From: Rooney, John
Sent: Wednesday, November 14, 2012 2:59 PM
To: Payne, Nancy
Subject: FW: 5695-00 Mount Pleasant, WI (Wright Avenue Concurrence)
Attachments: 10-067 P&P STH 31 & Wright Avenue (3D).pdf; Regulatory.pdf

WRIGHT AVENUE STRIPING PLAN
 WALMART STORE NO. 5695-00
 5425 WASHINGTON AVENUE
 FOUNT PLEASANT, WI 53126
 FILE 410-067-SATL-PA-WY 25 PT PLEASANT US-G-DRAWINGS-10-067 P&P STD 36 X 48-HI-AVAIL-080209-0-007

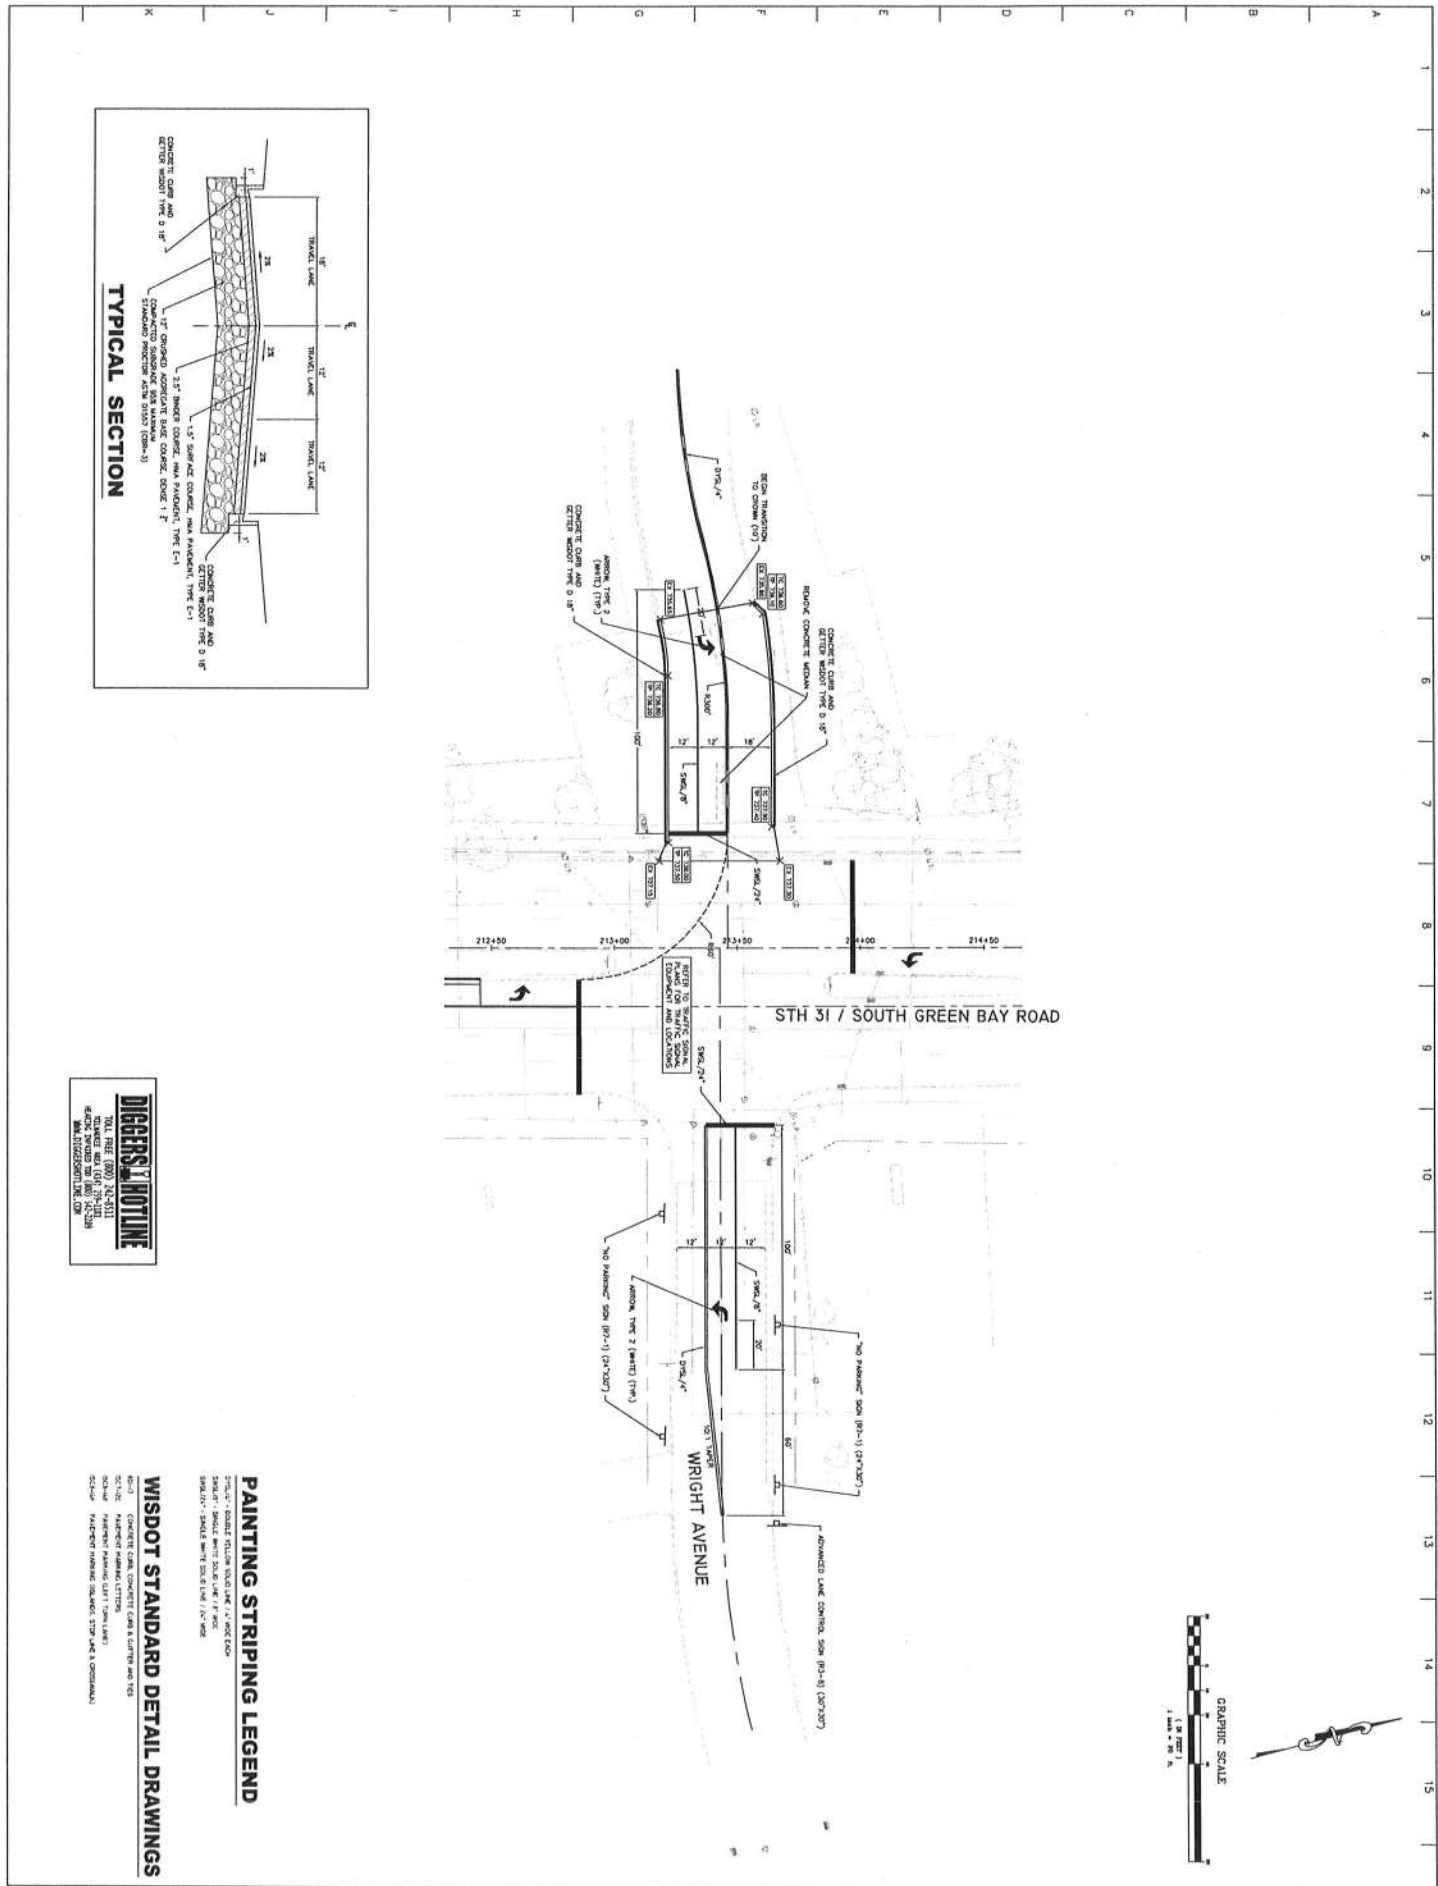
You'll need to provide at least 4 NPAT signs with arrows designating the direction. I have no objections to the request, but this must go before Traffic Commission and Common Council for approval. No "conditional" approval can be granted at this time. Let this e-mail serve as no objection by the City Engineer.

We are working on a Walmart development on the SW corner of STH 20 & STH 31. Part of our project includes offsite improvements to the intersection of STH 31 and Wright Avenue. WisDOT is requiring that we add traffic signals to this intersection, add a northbound left turn lane on STH 31 and re-stripe Wright Road to add a 100' left turn lane.

Please review the attached plan and provide comments and/or your approval of our proposed re-striping improvements on the east leg of the Wright Avenue intersection. I have also left you a voicemail. If you have any questions or concerns, please feel free to contact me. We are looking to submit our permit application on Wednesday, and we are looking to get concurrence from the City before submitting. Thank you.

Attached is the revised Wright Avenue Striping Plan per your comments. I've also attached the NAPT sign with arrow designation for your reference.

Attached is the revised plan for Wright Avenue, per your comments during our telephone conversation. Please provide us with written concurrence of these improvements, with the condition of committee approval. Thank you.
